HCCSC Salamonie HVAC Replacement and Renovation

Project # 2024.0002
10-08-2024

ADDENDUM NO. 02

MDI.1

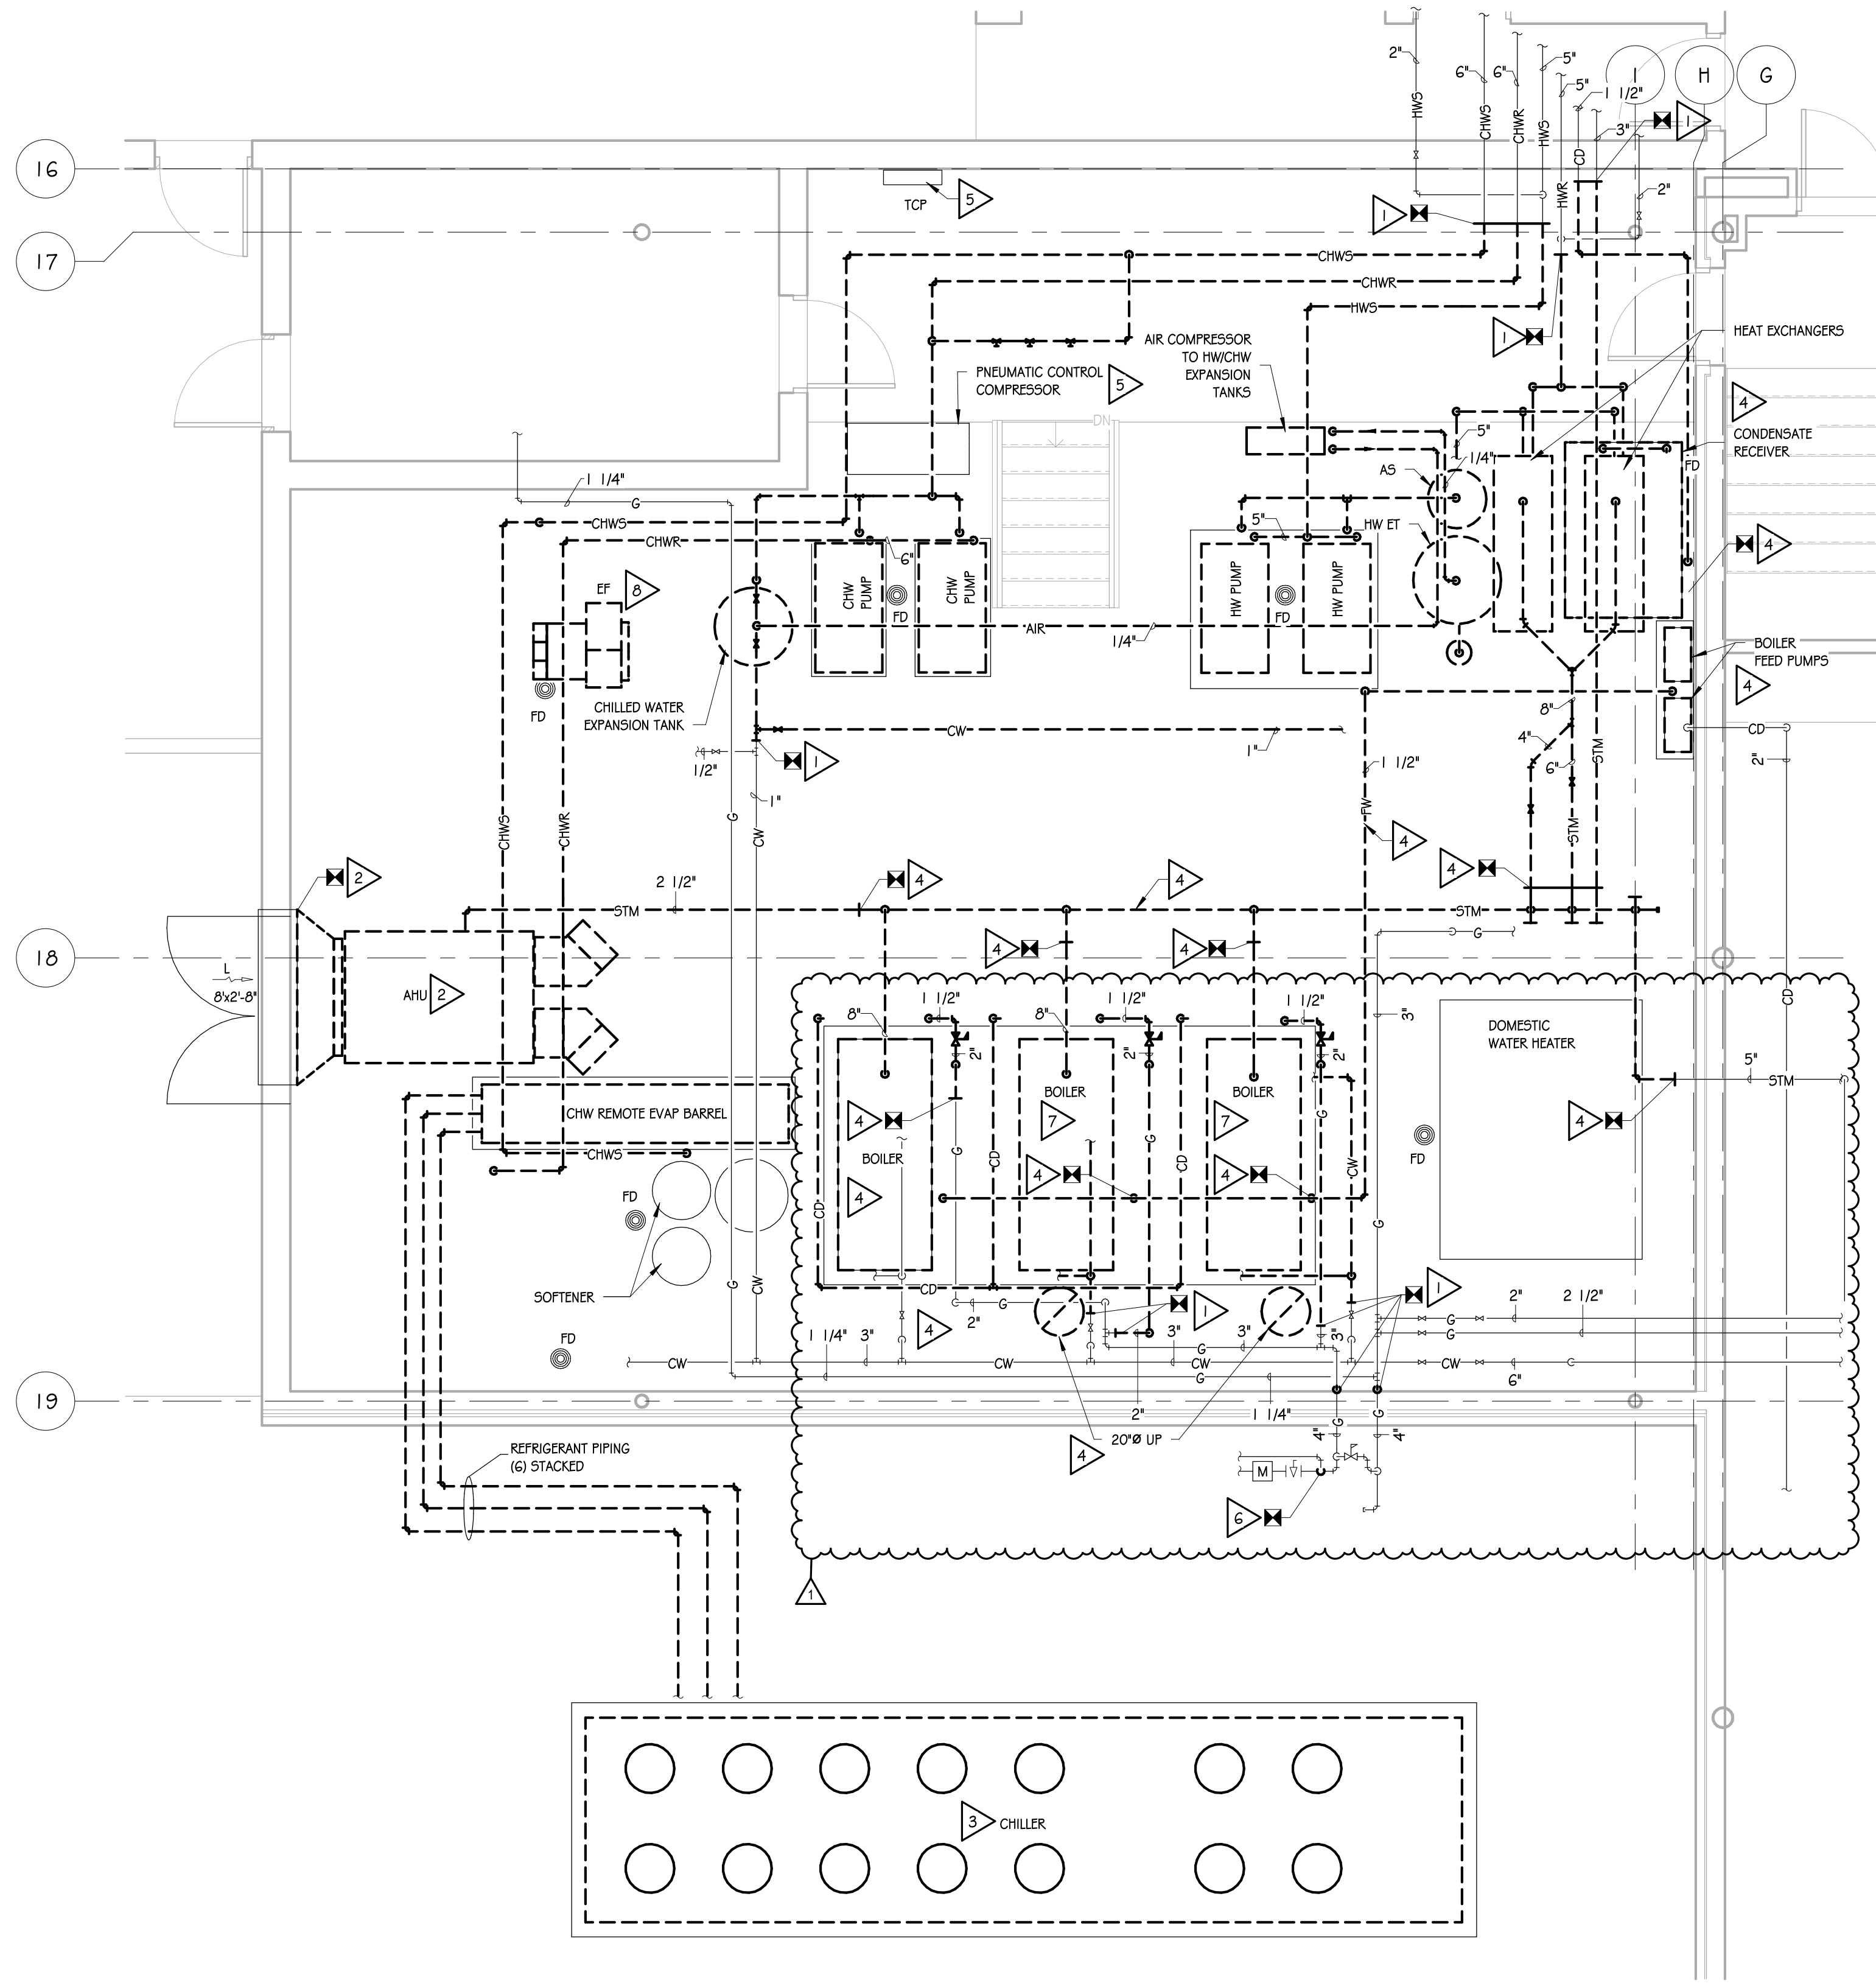
- Item: M-2.1**
Location: Specification: Section 230993 – Sequence of Operations for HVAC Controls
Description: Add: Specification section added.
- Item: M-2.2**
Location: Mechanical Drawings: MD1.1
Description: Revision: Revise the gas piping on the mechanical demolition plan – phase 1 as shown on attached revised sheet MD1.1.

MI.1

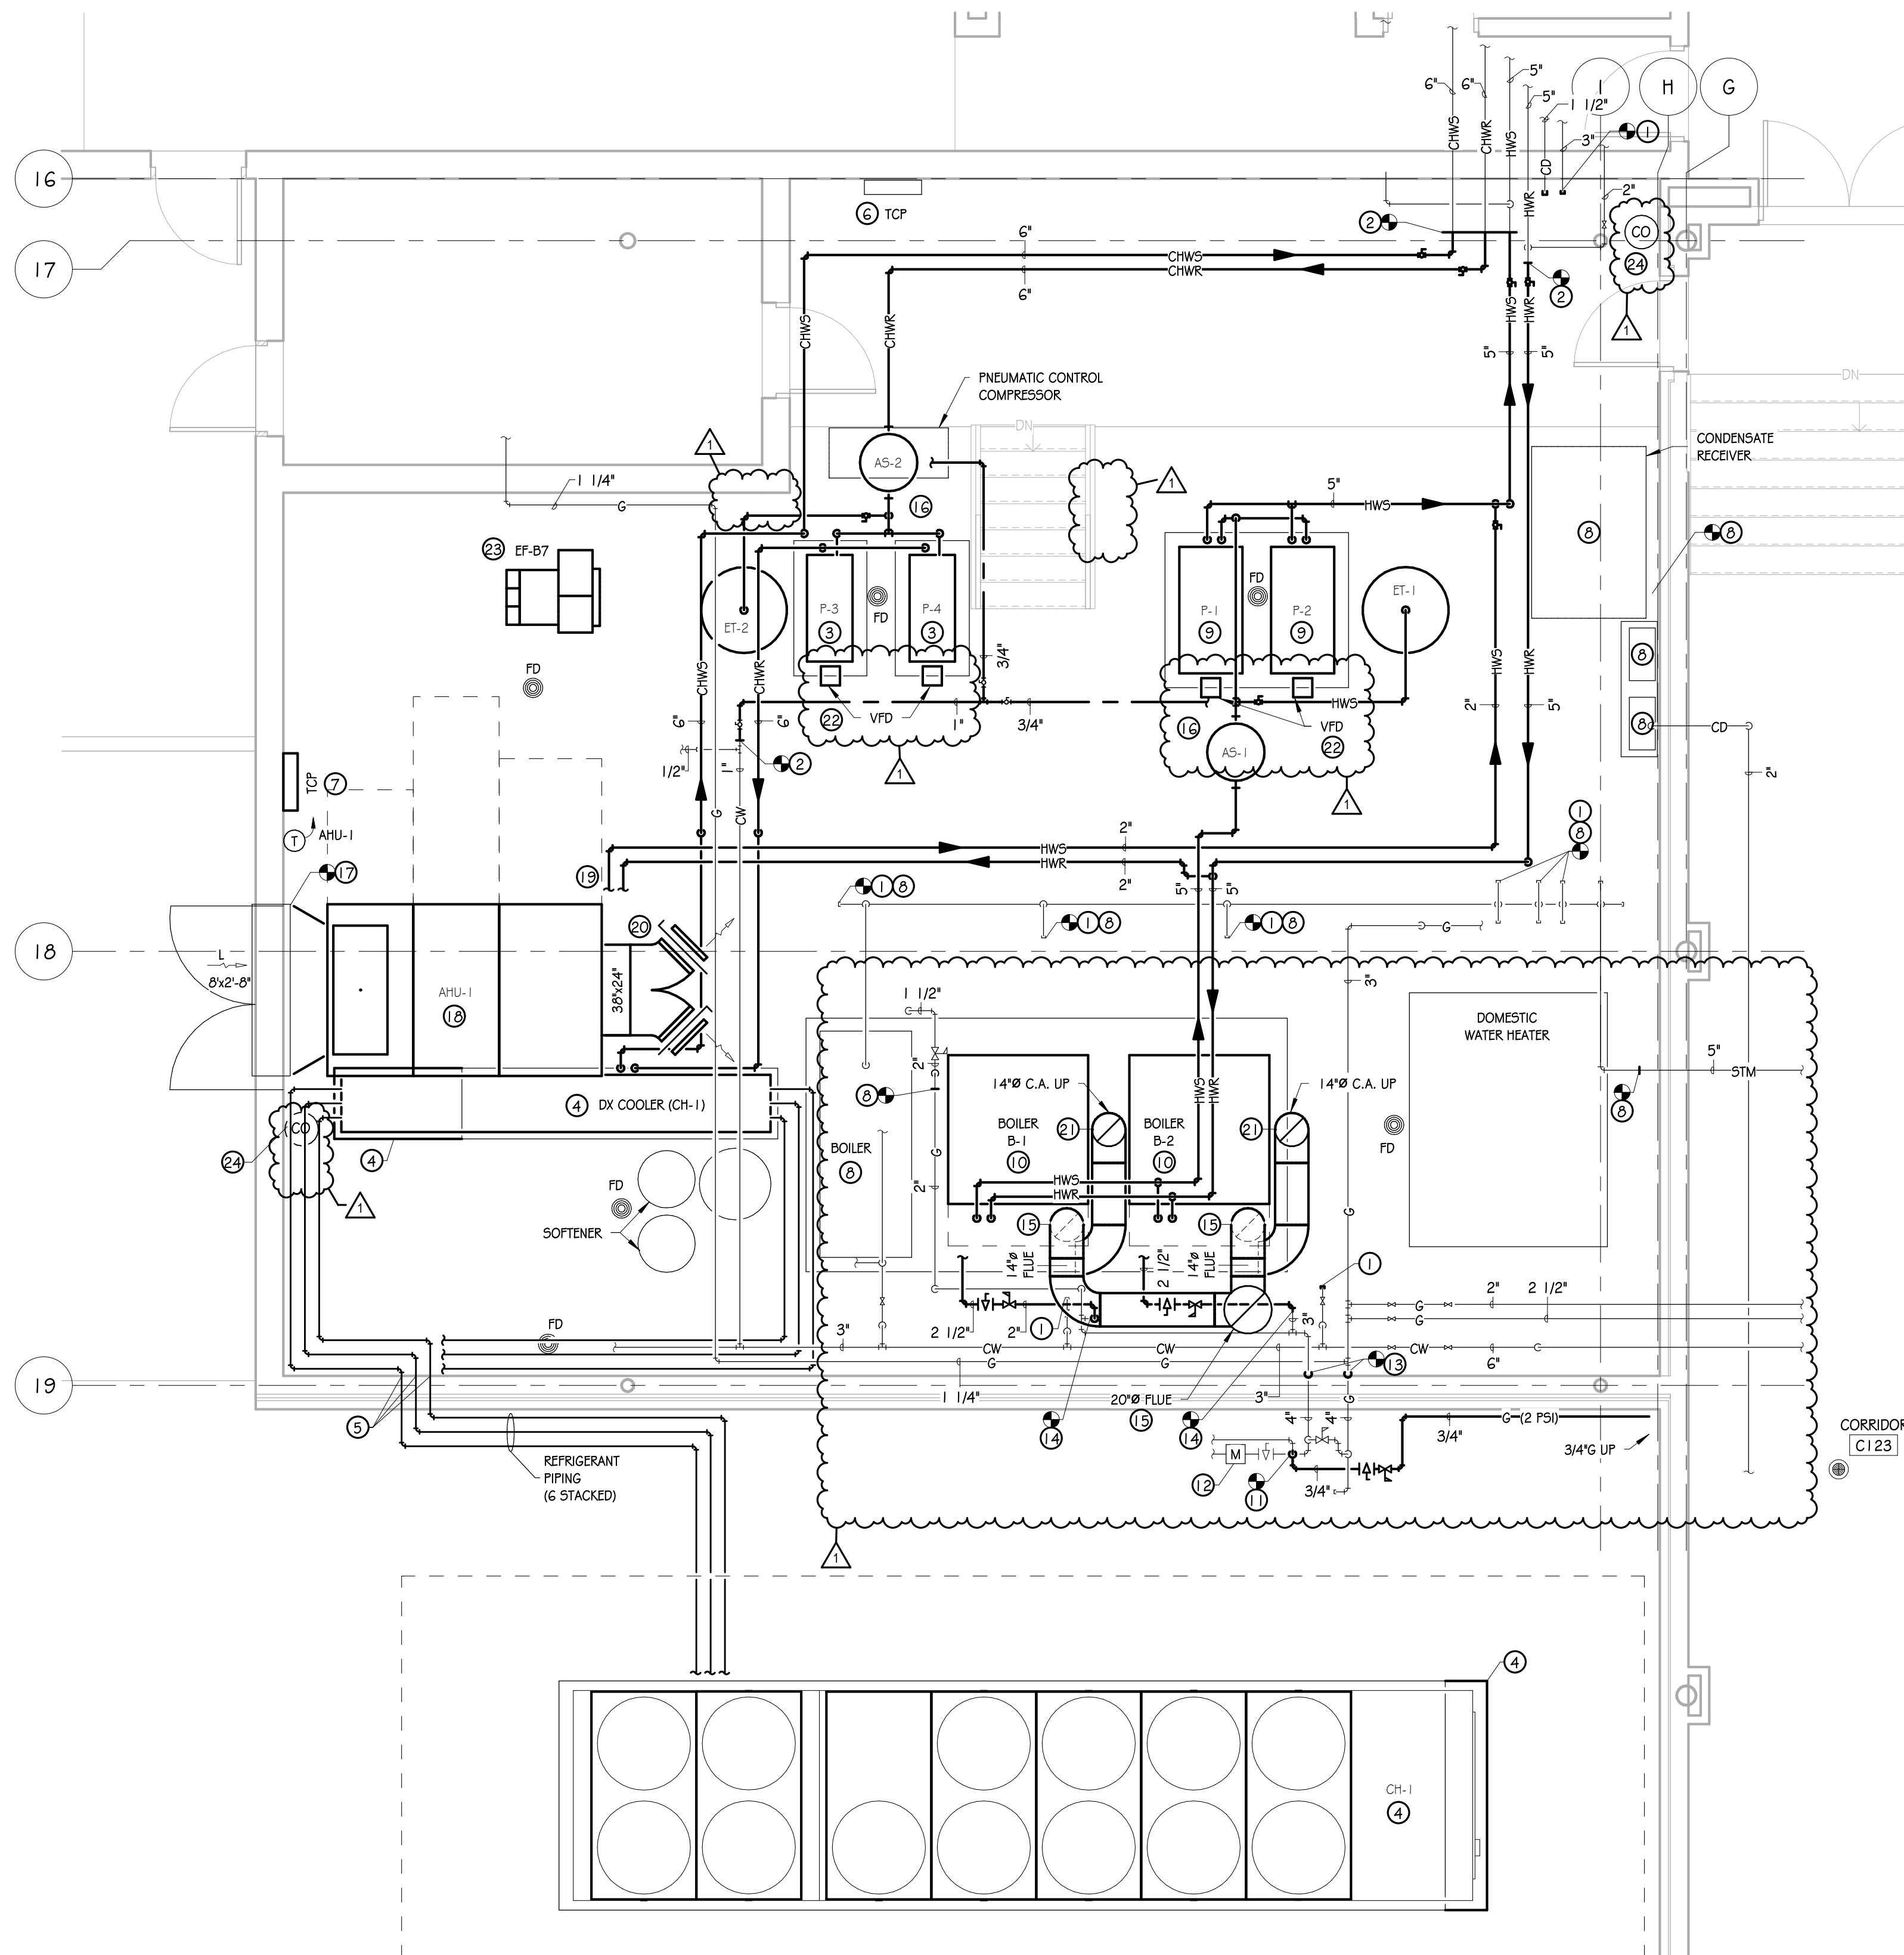
- Item: M-2.3**
Location: Mechanical Drawings: M1.1
Description: Revision: Revise the gas piping and pump VFD locations on the mechanical plan – phase 1 as shown on attached revised sheet M1.1.

MI.5

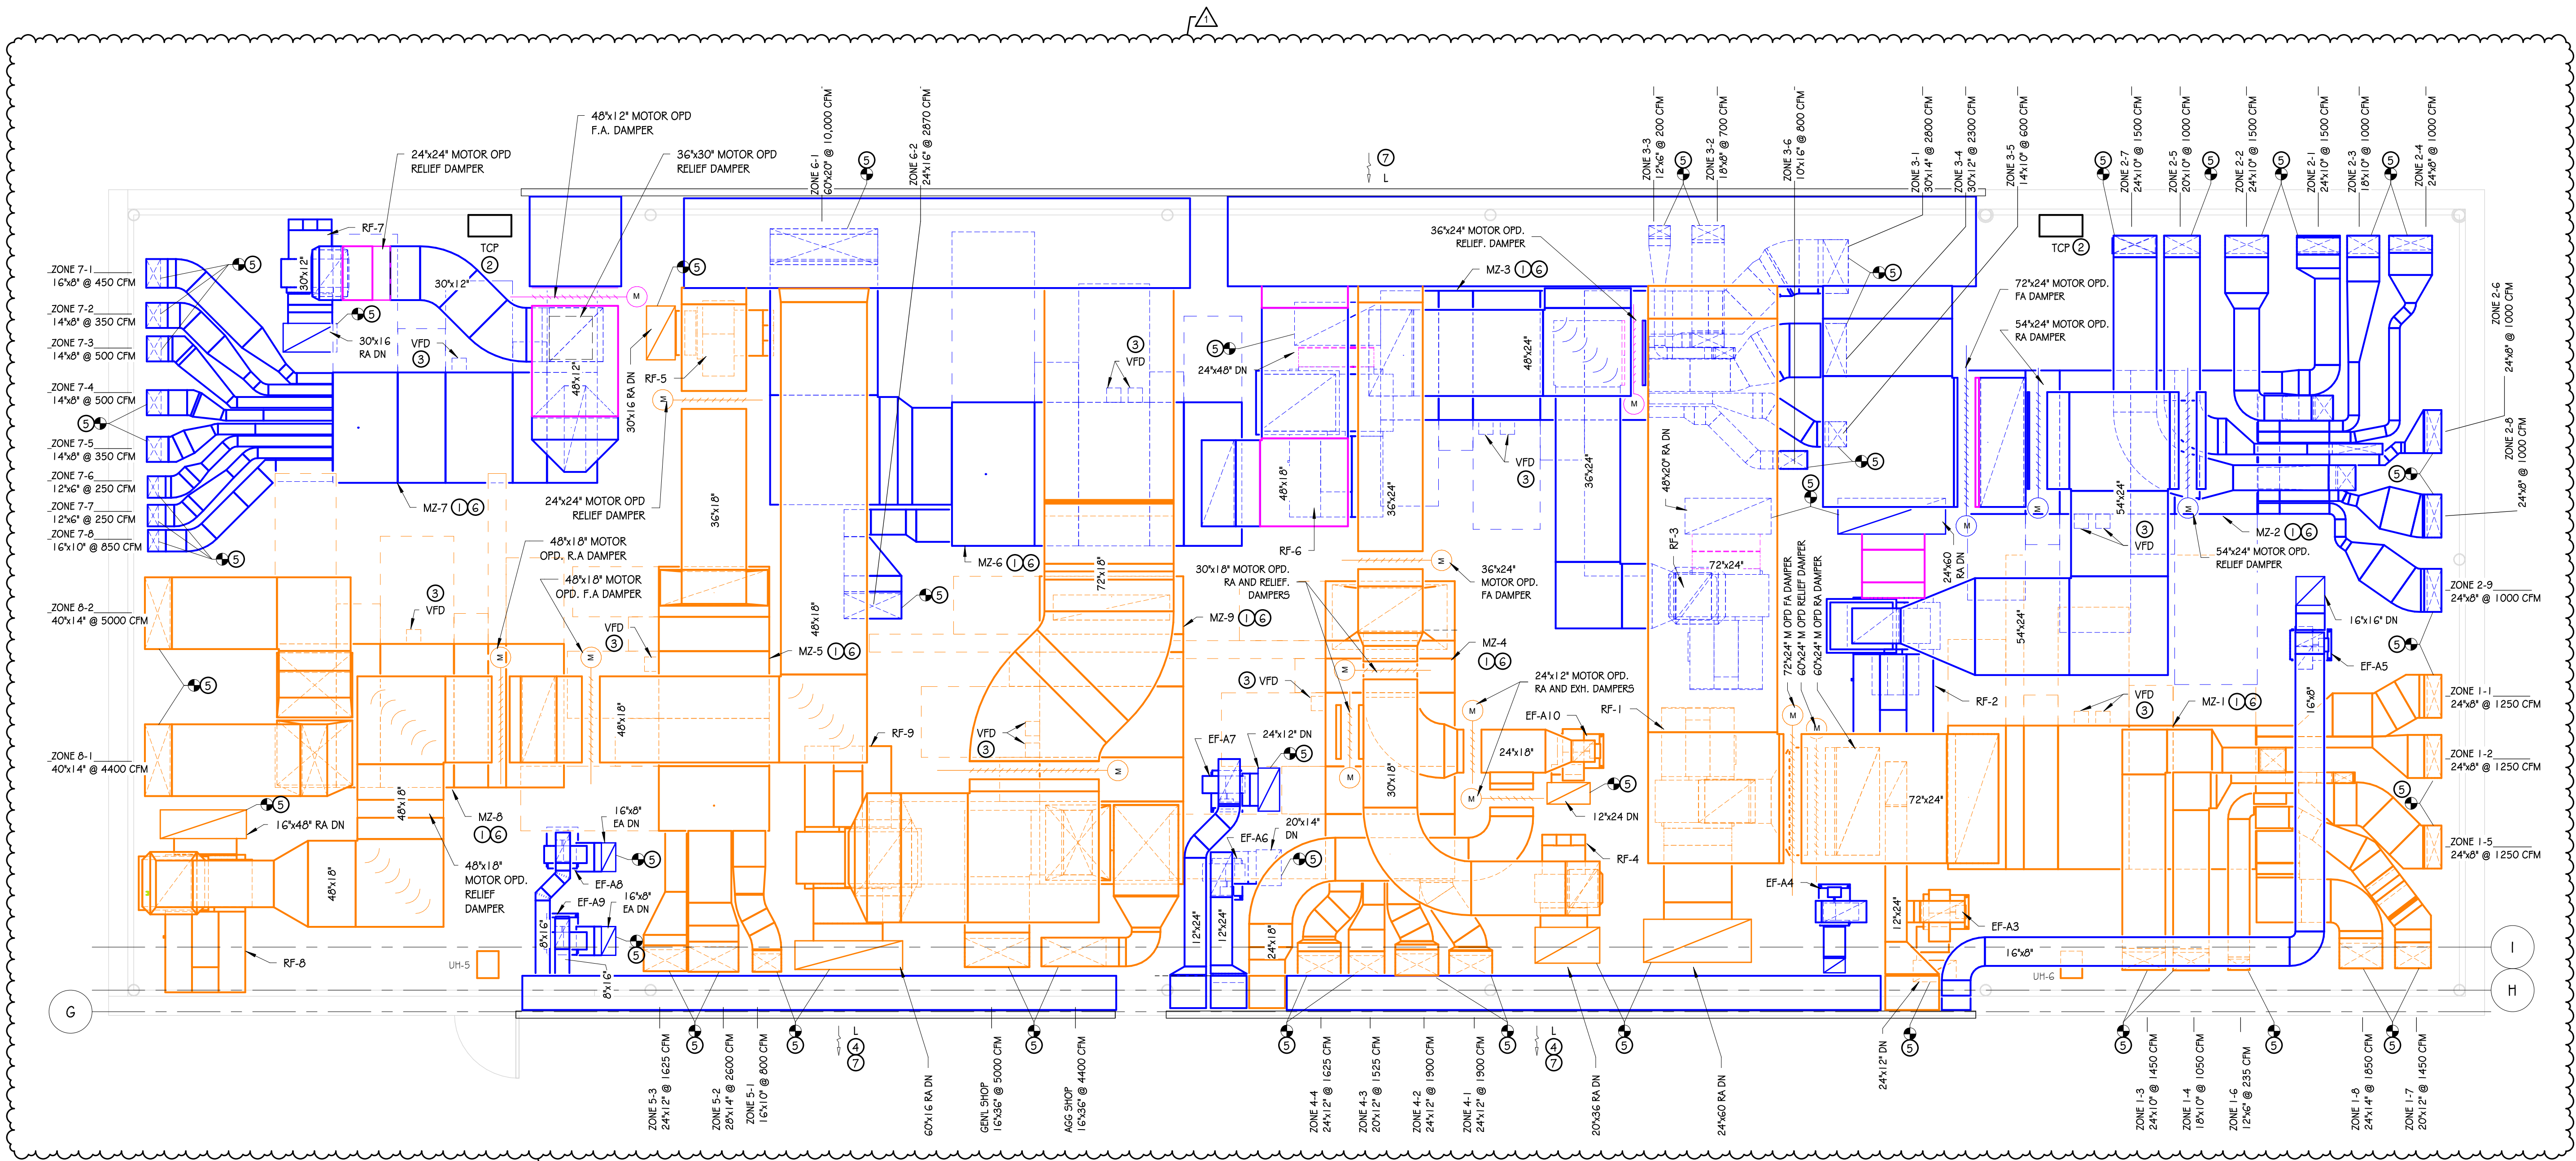
Q2: Note #4 refers to relief air dampers, no relief air ducts are shown on the plans.

Q3: On north end of Penthouse there are 2 ducts 40/14 which comes out of the floor with elbows and go to what?

Q4: MZ-6 supply duct are misaligned, or something.

Q5: RF-6 is ducted to the outside air duct and not connected to the return and no control dampers are shown.

Q6: On Units MZ-5, MZ-7 it appears that the return duct ties into the outside air duct, but no control dampers?

- Item: M-2.4**
Location: Mechanical Drawings: M1.5
Description: Revision: Revise the mechanical HVAC – Penthouse plan as shown on attached revised sheet M1.5.

A2: See revised mechanical drawings in Addendum no. 2.

A3: See revised mechanical drawings in Addendum no. 2.

A4: See revised mechanical drawings in Addendum no. 2.

A5: See revised mechanical drawings in Addendum no. 2.

A6: See revised mechanical drawings in Addendum no. 2.
